UNITED STATES PATENT AND TRADEMARK OFFICE

APPLICATION NO.	FILING DATE	FIRST NAMED INVENTOR	ATTORNEY DOCKET NO.	CONFIRMATION NO.
09/531,135	03/17/2000	Tohru Watanabe	005586-20035	5243

Office Action Summary

DETAILED ACTION

Fig. 3

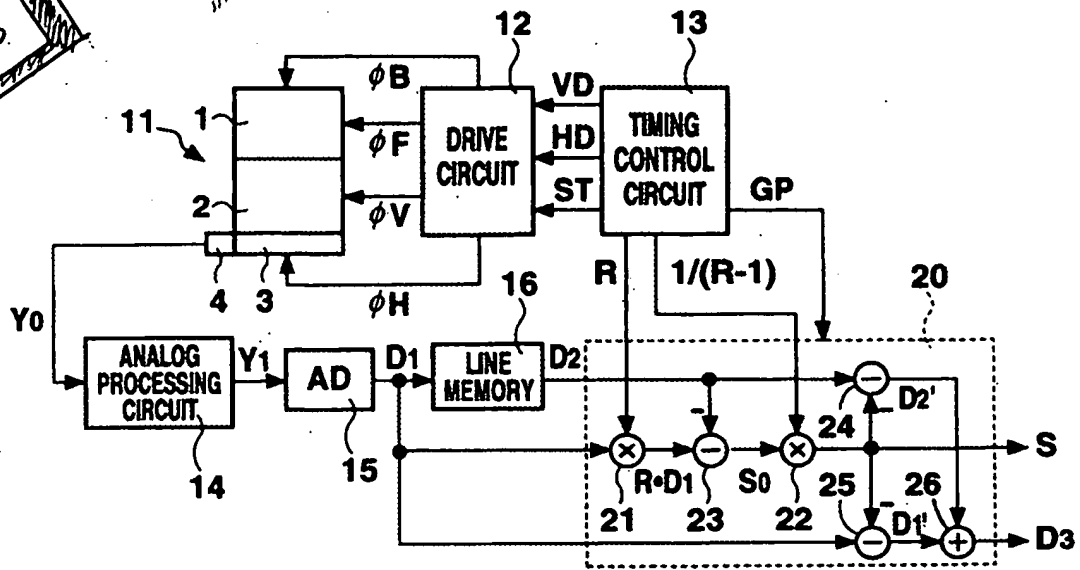
1. Applicant's arguments filed July 14, 2005 have been fully considered but they are not persuasive. However, Applicant's amendment to Figure 3 overcomes the previous objection; there are no further objections.
